Subject: Submission of Additional Round 2 Information Requirements Associated with the Flemish Pass Exploration Drilling Program

Additional Round 2 Information Requirements

**Flemish Pass Exploration Drilling Program
(CEAR 80129)**

**Eastern Newfoundland Offshore Exploration Drilling Project
(CEAR 80132)**

Figure 1 EIS Figure 5-70: Ensemble Agreement of Project Near-Surface Ocean-Water Temperature Predictions

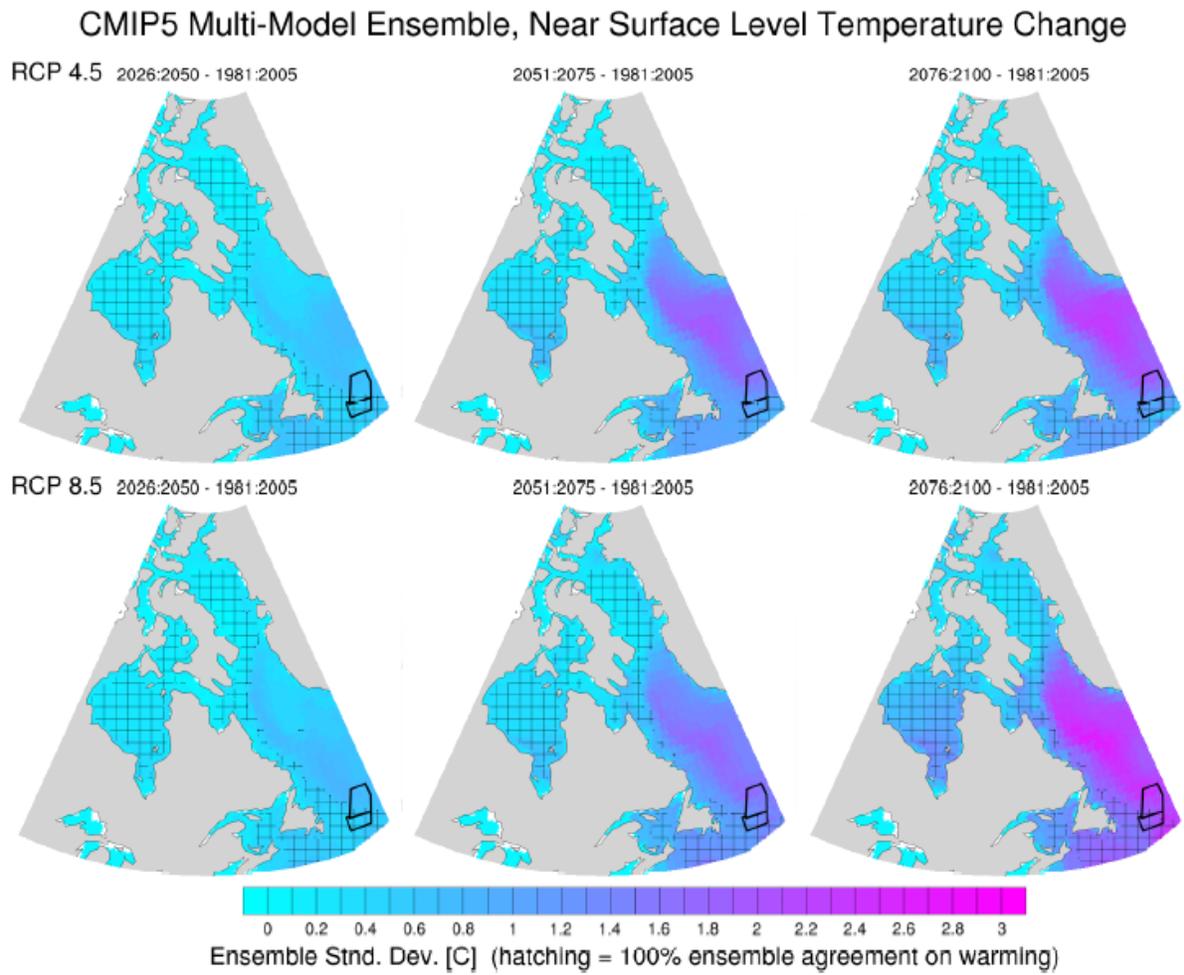
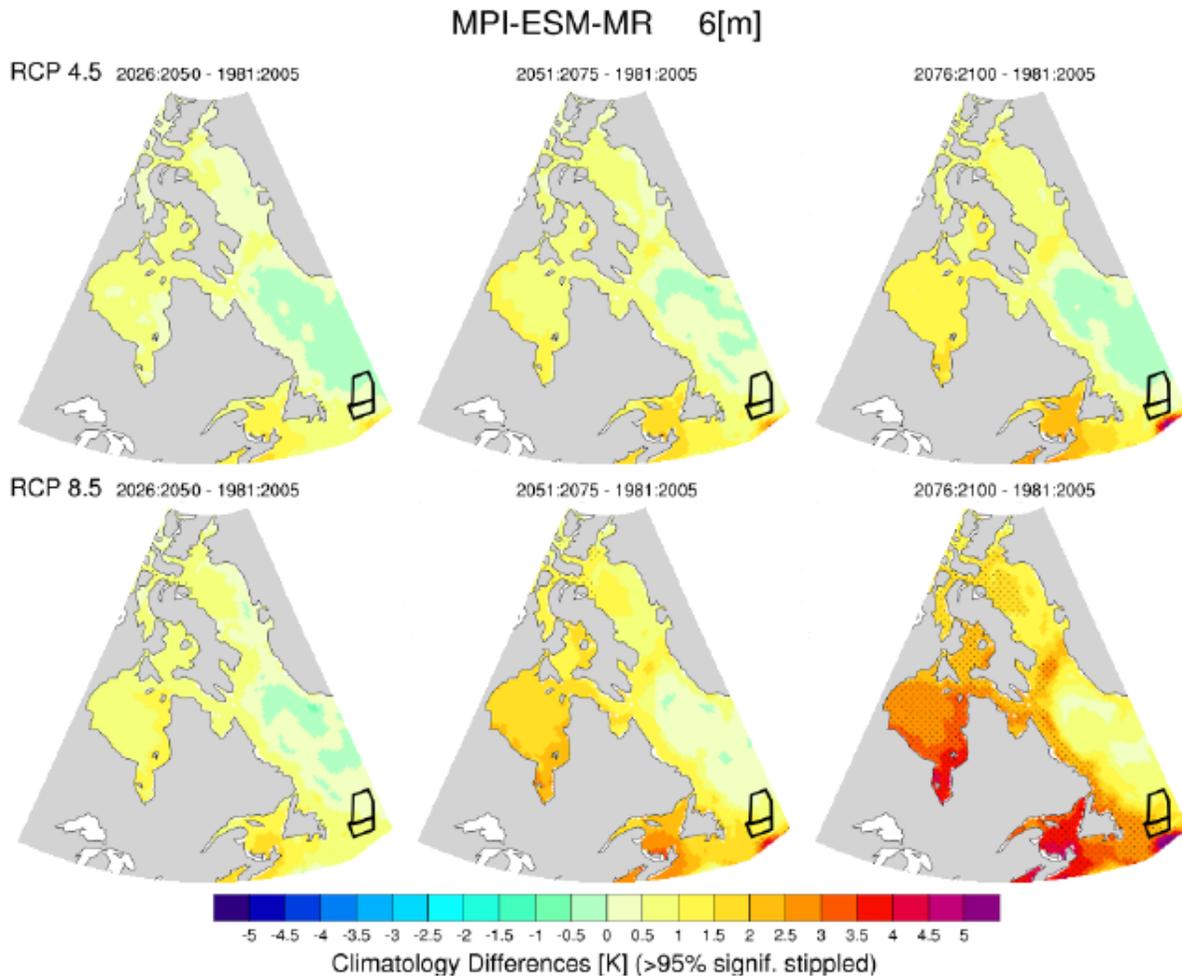
Provide clarification on contradictory information regarding sea-surface temperatures in the project area and the potential contribution this may make to current and future habitat use trends, taking into consideration the newly published research on sea-surface temperatures and Atlantic Salmon distribution.

The information provided in the original response to this IR (i.e. IR-16/16a Parts 1 and 3) appears to contain contradictory information and therefore additional clarification is provided below. As outlined in Part 1 of the original IR response, migration routes for Atlantic salmon can change based on environmental conditions such as SST, which can vary considerably within the marine environment. In terms of habitat preferences, it has been shown that avoidance of lower water temperatures, particularly below 3°C (Reddin and Shearer 1987; Reddin and Friedland 1993), can be used as a predictor of habitat use near the Grand Bank and Flemish Pass. Preferred water temperatures range between 4°C to 8°C (Reddin and Friedland 1993).

Predictions related to climate change and ocean-water temperatures were provided in Section 5.8.2.1 of the EIS. Model results were provided for three time-period end-dates; 2050, 2075, and 2100. As with all model predictions, estimates of uncertainty and model agreements (if multiple models are used) provide an indication of the reliability of predictions. Figure 5-70 in the EIS (reproduced as Figure 1 below) shows the level of model agreement and the standard deviation of projected temperature changes of near-surface water (5 to 7 m depths) in the North Atlantic. Areas with cross hatching have 100 percent model agreement (based on an ensemble of seven CMIP5 global climate models) that warming will occur in these areas. The background colours within each model output represent the standard deviation of the magnitude of warming projected, which is a representation of uncertainty. As shown, the models had greater standard deviations and limited agreement within the majority of the Project boundary area, indicating greater uncertainty in the predictions. Figure 5-71 from the EIS (reproduced as Figure 2 below) shows a representative Global Climate Model projection from the same model ensemble used to create Figure 5-70 from the EIS. The predictions indicate that the next several decades (to approximately 2075) will experience near-surface (top 6 m) water temperatures 1°C to 1.5°C warmer than that recorded in 1981-2005.

Statistical summaries of sea temperature were derived for the same rectangular area surrounding the Project Area as that shown in Figures 5-70 and 5-71 of the EIS. Mean SSTs range from 1.6°C in March to 5.3°C in October. Minimum temperatures at the surface range from -1.8°C in January to 1.1°C in August and September. Maximum SSTs range from 4.0°C in March to 11.8°C in August. As shown, mean SSTs values greater than 3°C occur between July and November and the preferred range (4°C to 8°C) can occur between July and October. Minimum SSTs for every month are below 3°C.

As indicated, the mean predicted SSTs are below the preferred range (i.e., lower suitability) but above the temperature known to be physically avoided. Therefore, the statement within the original response to this IR remains unchanged; the limited interaction between salmon migrating within and near the Project Area and those post-smolt and adults feeding north in the Labrador Sea and kelts along the southern edge of the Grand Bank will most likely remain low given the predicted increases in SSTs (i.e., lower suitability) near the Project Area. As the potential for environmental effects of planned Project activities and overall risk to Atlantic salmon is low, it is not predicted that the Project will contribute to or exacerbate declines to salmon populations. As a result, the conclusion within the EIS based on existing data remains valid; the Project is not likely to result in significant adverse environmental effects on marine fish and fish habitat, including Atlantic salmon.

Figure 1 Other Projects, Including Proposed BdN Project, and Activities Considered in the Cumulative Effects Assessment (Including Distances from Project Area – Northern Section)

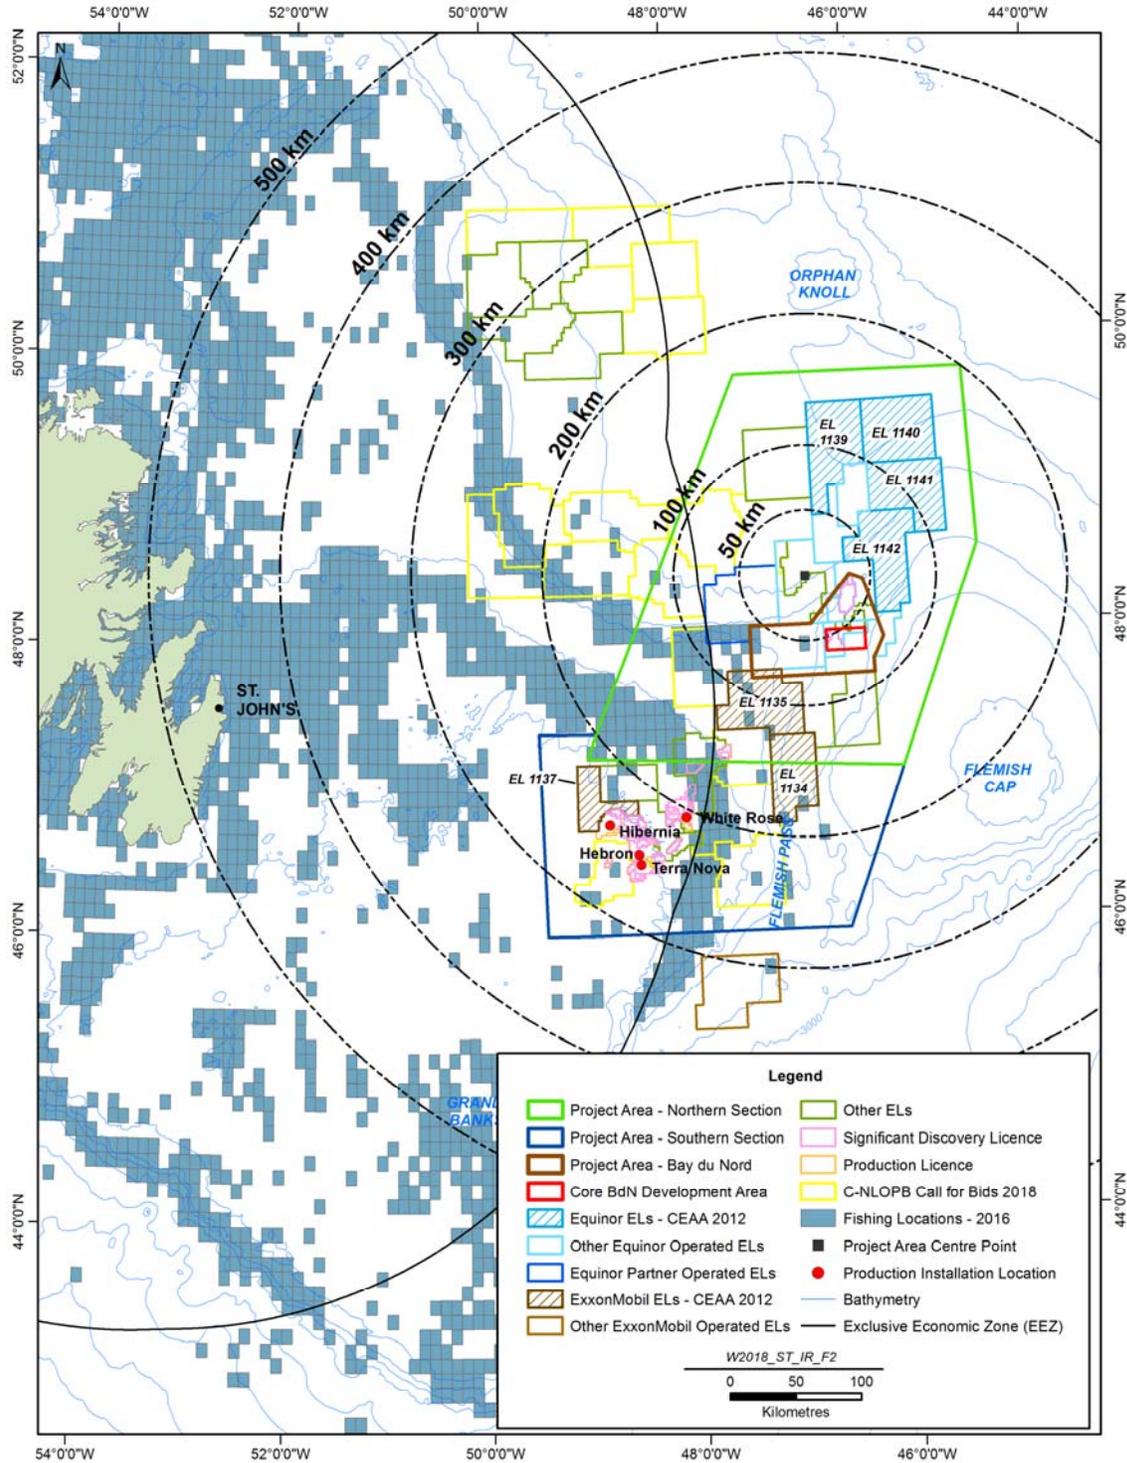
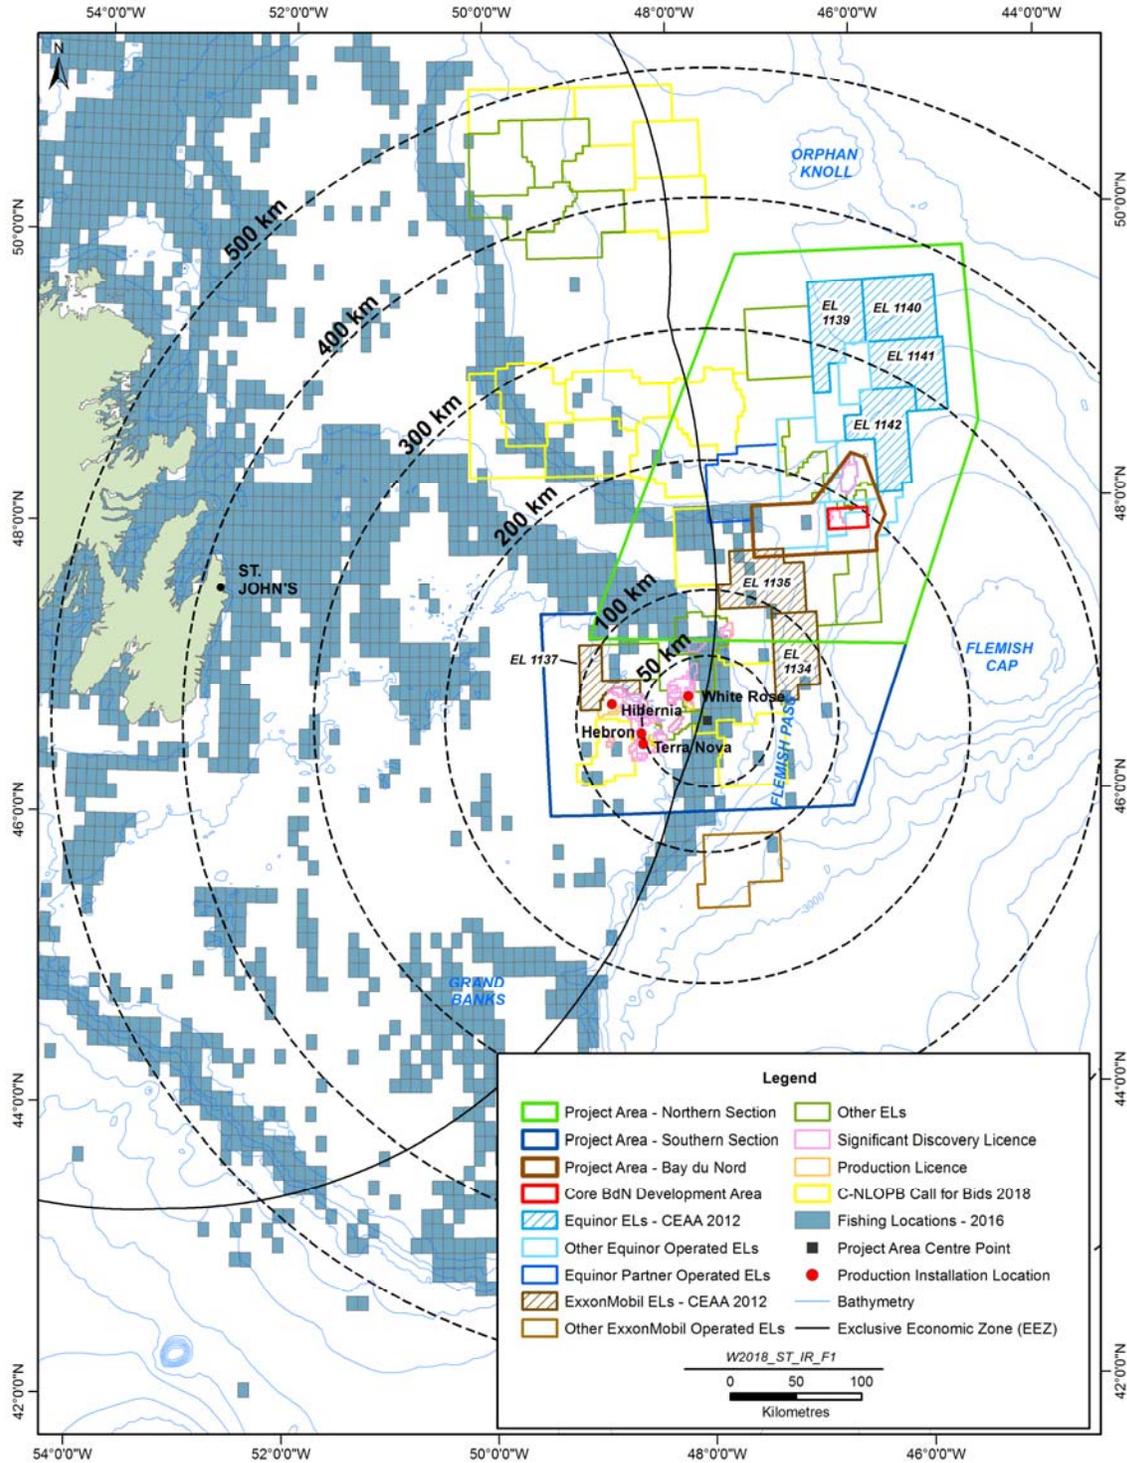
Update the assessment of cumulative effects, taking into account taking into account projects and activities that have been proposed since the EISs were prepared.

An overview of the proposed BdN project is outlined in Table 1 below. Figures 1 and 2 (updates to EIS Figures 14-1 and 14-2) have been updated to include the location of the proposed BdN project. The Operators have also taken the opportunity to incorporate general updates to Figures 1 and 2 (e.g. fishing locations, call for bids).
